ADDENDUM 01 SOFTBALL UPGRADES

Project #: 0323.25.002

Project Name: Softball Upgrades
Vicksburg High School – 3701 Drummond St., Vicksburg, MS 39180
Warren Central High School – 1000 MS-27, Vicksburg, MS 39180

**SITE DEMOLITION PLAN
(VICKSBURG HIGH SCHOOL SOFTBALL)**

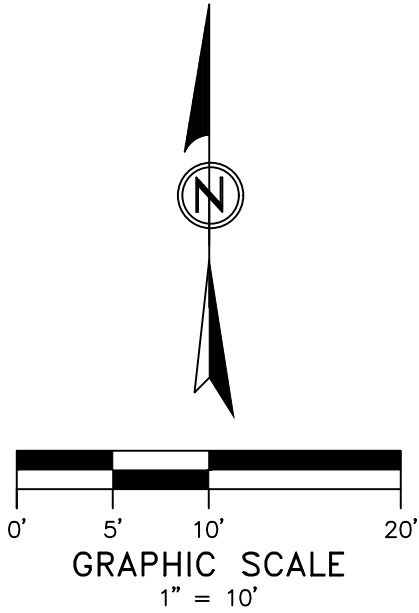
- C1. Civil: Replace these sheets in their entirety.
1. C100 – Site Demolition Plan (Vicksburg High School Softball)
 2. C200 – Civil Site Plan (Vicksburg High School Softball)
- C2. Mechanical: Replace these sheets in their entirety.
1. M601 – Mechanical Schedules
